Recall Campaign Bulletin

Campaign No. 2023110006, July 2024

Revision B: March 3, 2025

SIM Card Communication Module – Wave 3

Figure 12 (screen on "NetStar" if the OTA update was not successful)
 Status: Failed – Error during execution of the command on the SM-SR. Could not communicate with card.

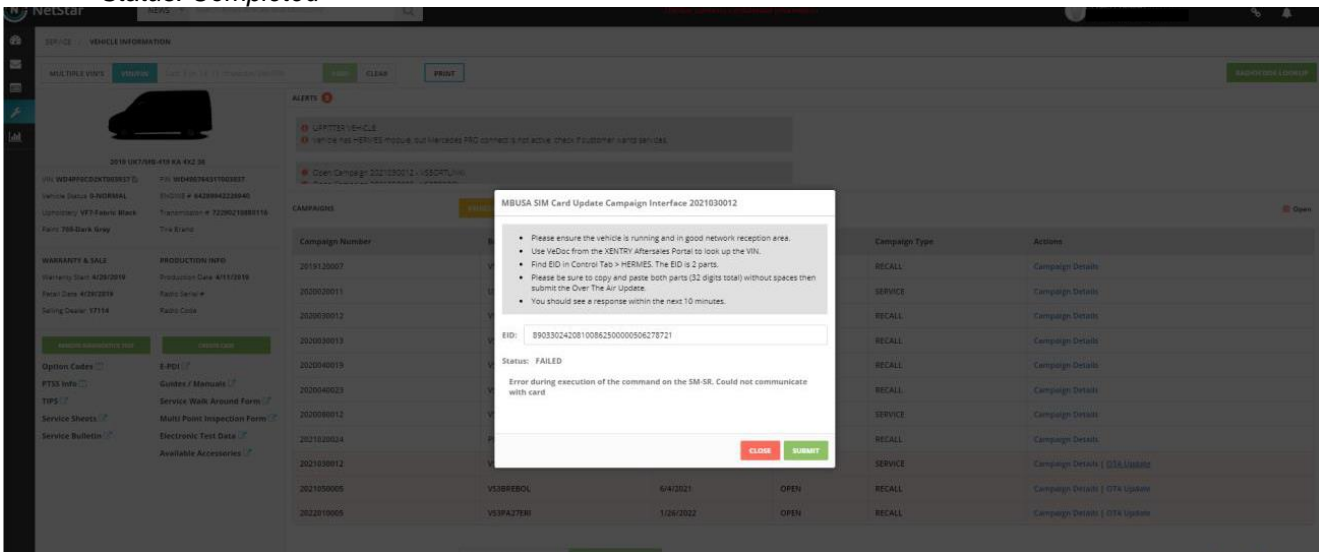
- Revised IMSI **Check/Test Procedure** via XENTRY Diagnosis.
- Requirement for documenting status of **ICCID/IMSI "FFFFFFFFFFFFFF"** in RO text.
- Changed number of over-the-air update (OTA update) retries in **Work Procedure 2**.

- The OTA procedure must be attempted a second time if the first attempt fails. Wait at least 7 minutes after the first attempt before retrying.** If the data of the SIM card in the HERMES control unit (N112/9) is **not updated** successfully OTA after the second attempt: Carry out **Work Procedures 3 and 4**.
- If the data of the SIM card in the HERMES control unit (N112/9) is **updated** successfully OTA: Carry out only **Work Procedure 4**.
